<b>marantz®</b> <b>SERVICE BULLETIN</b>		Date: 5-Mar.-2004	Model: SR5400,SR6400,SR7400
		Page: 1 / 1	REF.NBR: MZ04-019
Circulation:		Subject:	
Application:		By idling, Top cover becomes very hot so that it cannot touch by hand.	
x for information customer complaint in case of service mandatory .....		See below	
		Int.ref:

<b>marantz®</b> <b>SERVICE BULLETIN</b>		Date: 15-Mar.-2004	Model: SR7400
		Page: 1 / 1	REF.NBR: MZ04-025
Circulation:		Subject:	
Application:		Can't decode input signal by the operation of other company HDD RECORDER.	
x for information customer complaint in case of service mandatory .....	See Below		
		Int.ref:

<b>marantz®</b> <b>SERVICE BULLETIN</b>		Date: 9-Jan-2004	Model: SR7400
		Page: 1 / 1	REF.NBR: MZ04-003
Circulation:		Application:	
x for information customer complaint in case of service mandatory .....		See Below	
		Subject:  Sound cut (short-time) of Dolby and dts decoding.	
		Int.ref:

<b>marantz®</b> <b>SERVICE BULLETIN</b>		Date: 9-Jan.-2004	Model: SR7400
		Page: 1 / 3	REF.NBR: MZ04-004
Circulation:		Subject:	
Application:		The synchronization of picture is disturbed. ( Only PAL system video signal )	
x for information customer complaint in case of

**C281 REMOVAL PROCEDURE**

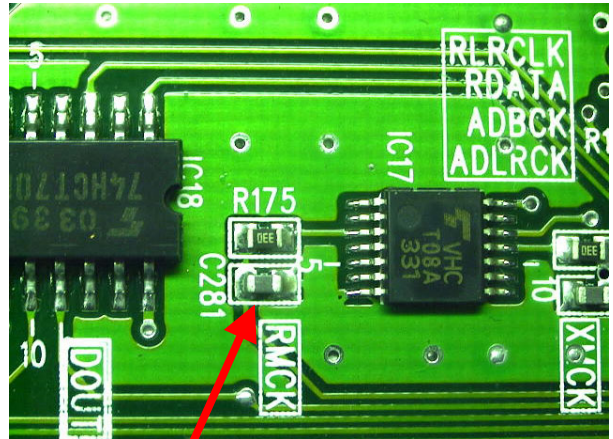
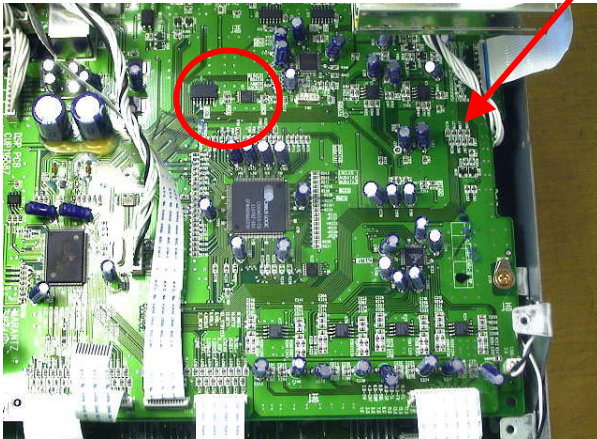
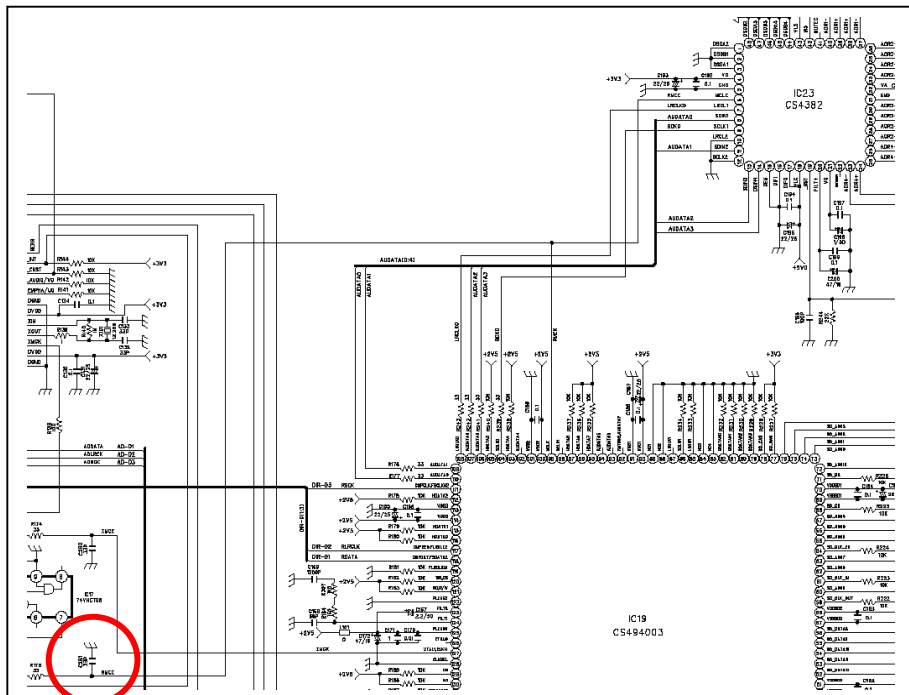
Capacitor C281 (33pF) of the measure against EMC has influenced.  
By the capacitor C281, the standup of a clock pulse becomes late, DSP incorrect-detects the noise, and Auto Mute of DAC incorrect-operates.

**Capacitor C281 ( 33pF) is removed on DSP PCB.**

- 1) Remove 9 screws of VIDEO PCB from REAR PANEL.
- 2) Remove 2 screws from VIDEO PCB.
- 3) Disconnect the connector and Flexible Flat Cable from VIDEO PCB.
- 4) You can remove VIDEO PCB, then you can see C281.
- 5) Remove C281.

**C281**

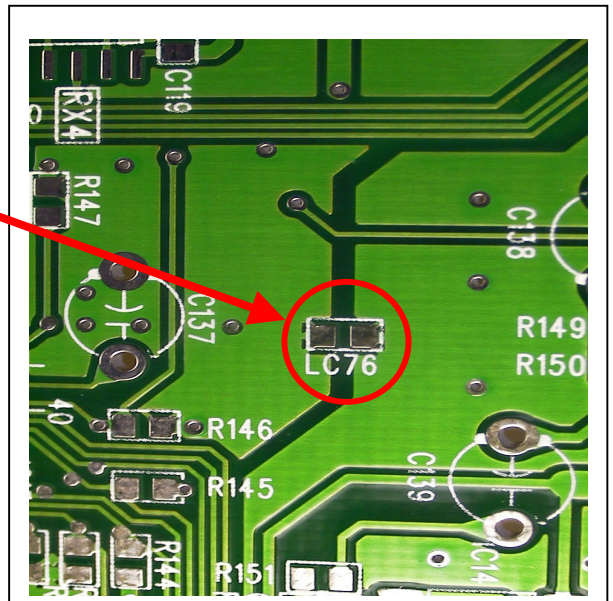
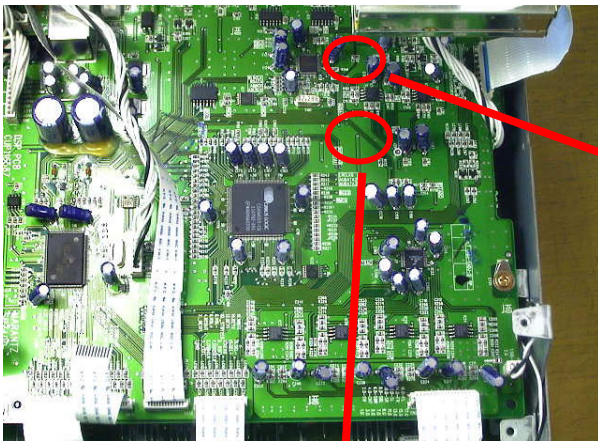
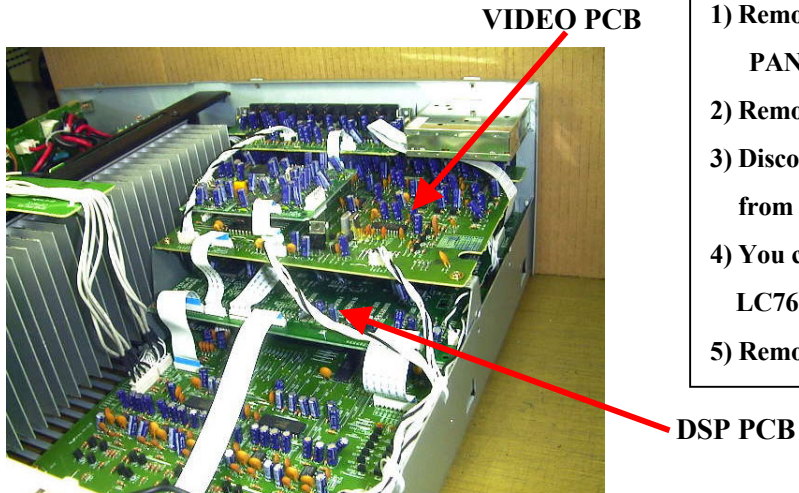
- 1) Noise occurs except 7.1CH INPUT and analog signal S-DIRECT.
- 2) When volume is increased, noise occurs.

- 1. Chip Resistor LC76 ( 0 ohm ) is removed on DSP PCB.**
- 2. Cut a GND-pattern on DSP PCB.**

- 1) Remove 9 screws of VIDEO PCB from REAR PANEL.
- 2) Remove 2 screws from VIDEO PCB.
- 3) Disconnect the connector and Flexible Flat Cable from VIDEO PCB.
- 4) You can remove VIDEO PCB, then you can see LC76.
- 5) Remove LC76 and Cut a GND-Pattern
